CITY OF BEAVERTON
DESIGN EXCEPTION REQUEST

Curb Return Radii Design Exception Request – Additional Information

Horizontal Alignment Design Exception Request – Additional Information

SW DENNEY ROAD
 SW 105TH AVE TO SW SCHOLLS FERRY ROAD
 WASHINGTON COUNTY

SHEET NO.
43 OF **84**
 SHEET TITLE
5

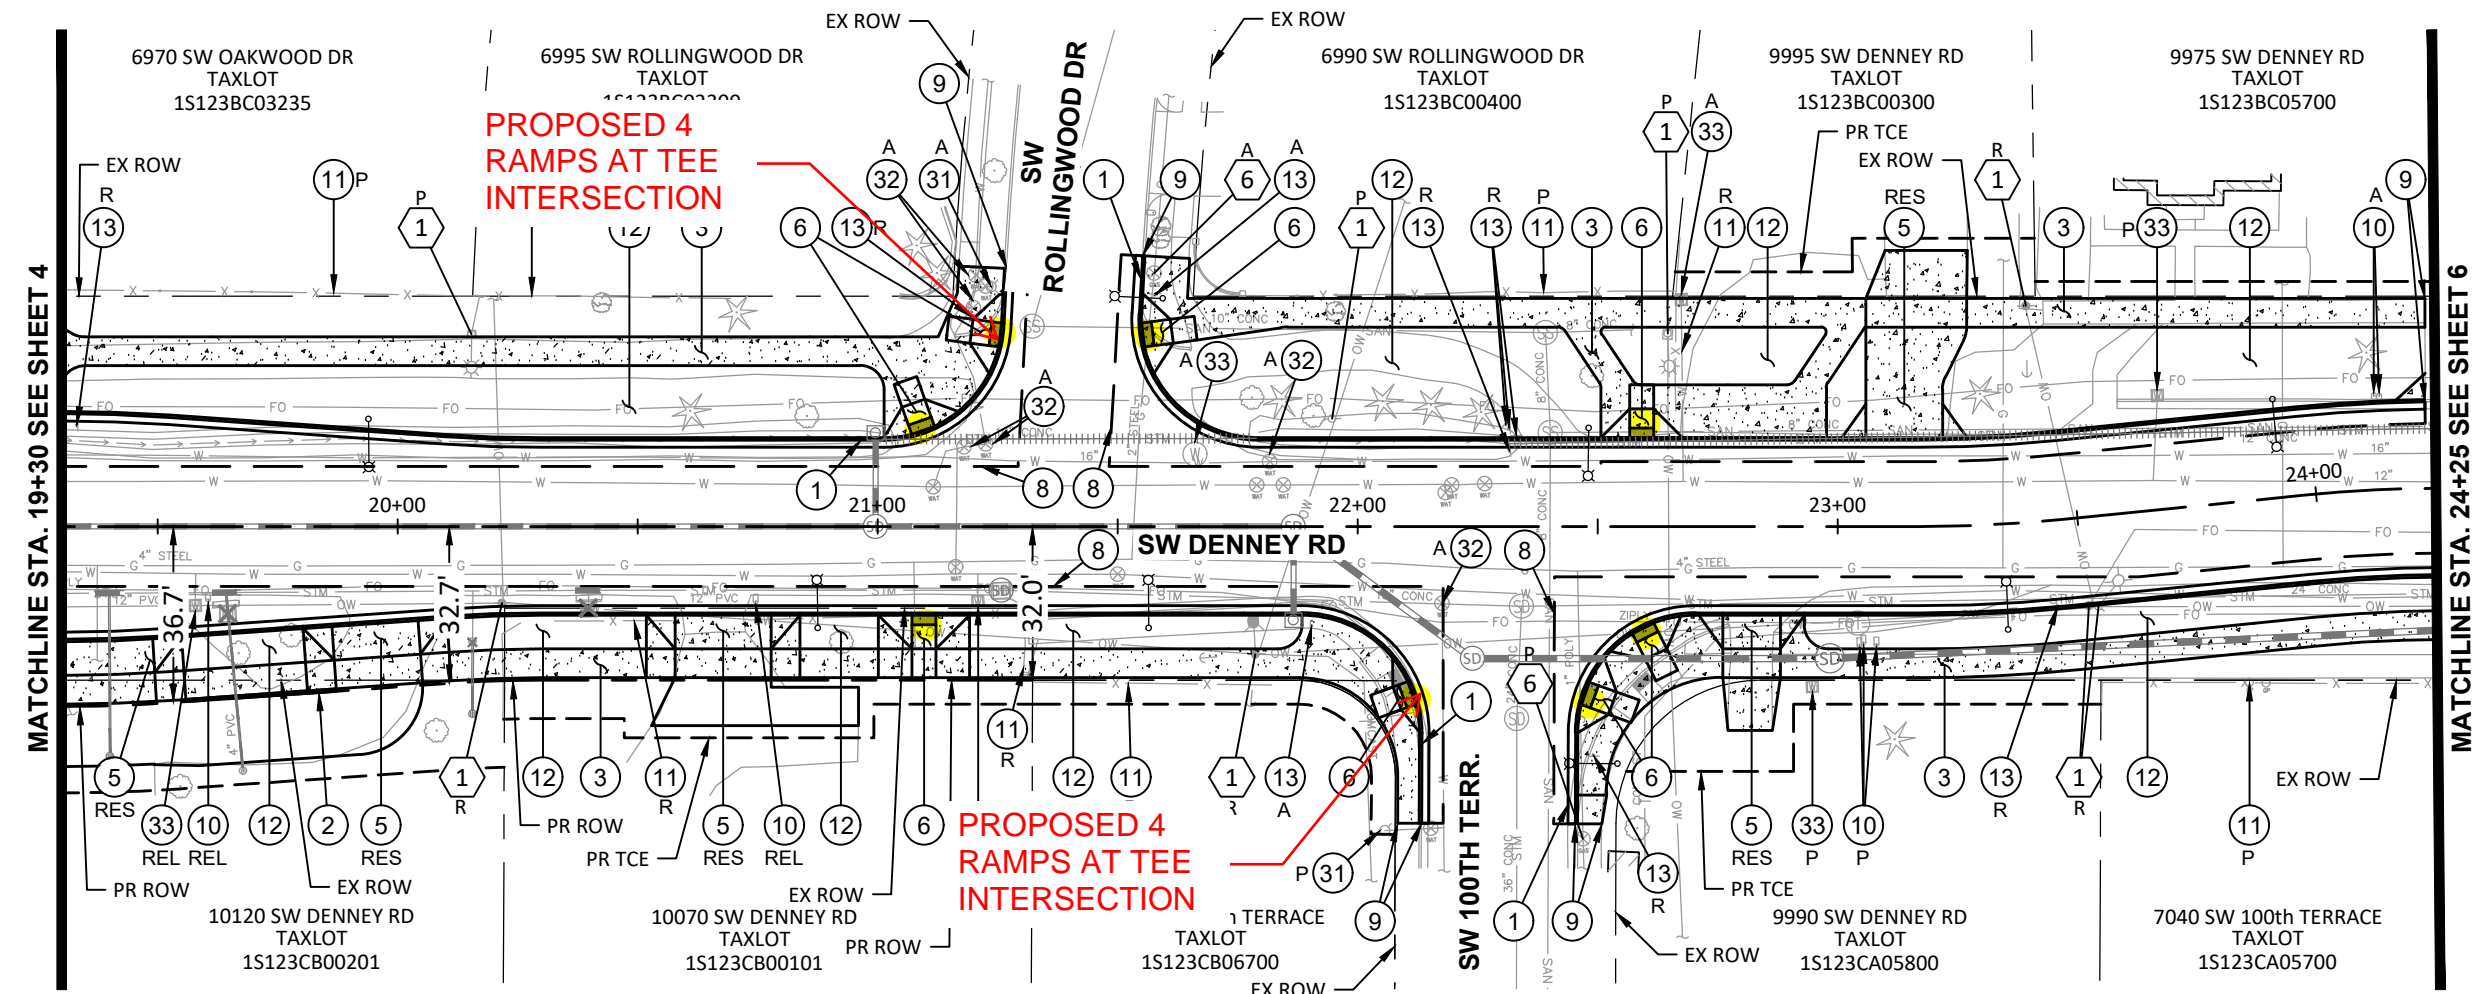
PROPOSED DESIGN MODIFICATIONS:

SW ROLLINGWOOD DR AND SW 100TH TERR AT SW DENNEY RD ACT AS AN OFFSET INTERSECTION. NO ADA RAMPS PROVIDED ON INTERIOR CROSSING DUE TO CONFLICT WITH SIGNIFICANT TREES ON THE NORTH SIDE.

SHEET NO.
45 OF 84
SHEET TITLE
6

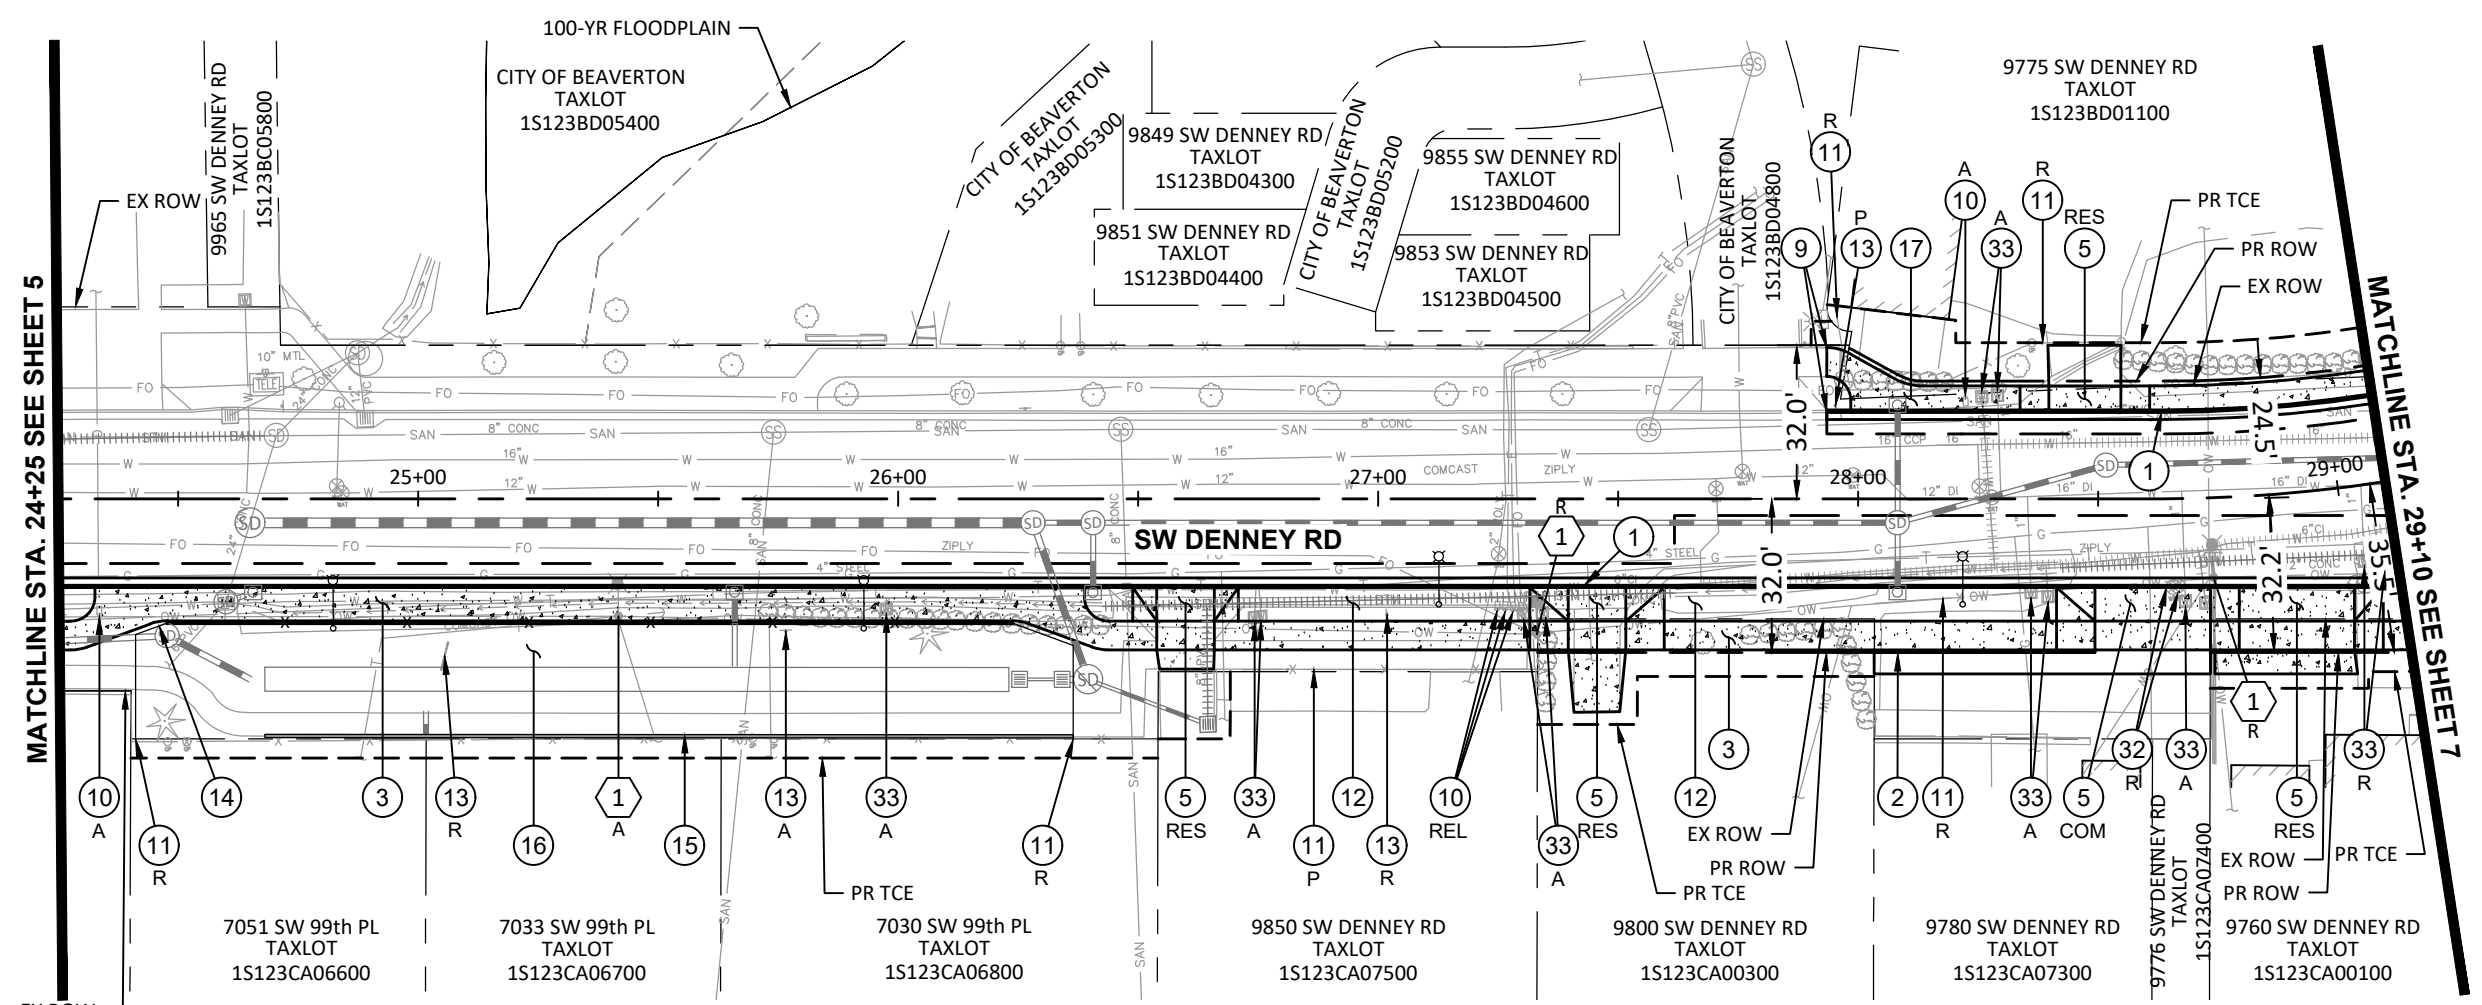
PROPOSED DESIGN MODIFICATIONS:

- 6' CURB TIGHT SIDEWALK - 24+32.64 RT. TO 26+38.85 RT. TO PROVIDE SPACE FOR AN EXTENDED DRY POND STORMWATER FACILITY.
- 6' CURB TIGHT SIDEWALK - 28+63.16 RT. TO 29+35.32 RT. TO AVOID IMPACTS TO TREES.
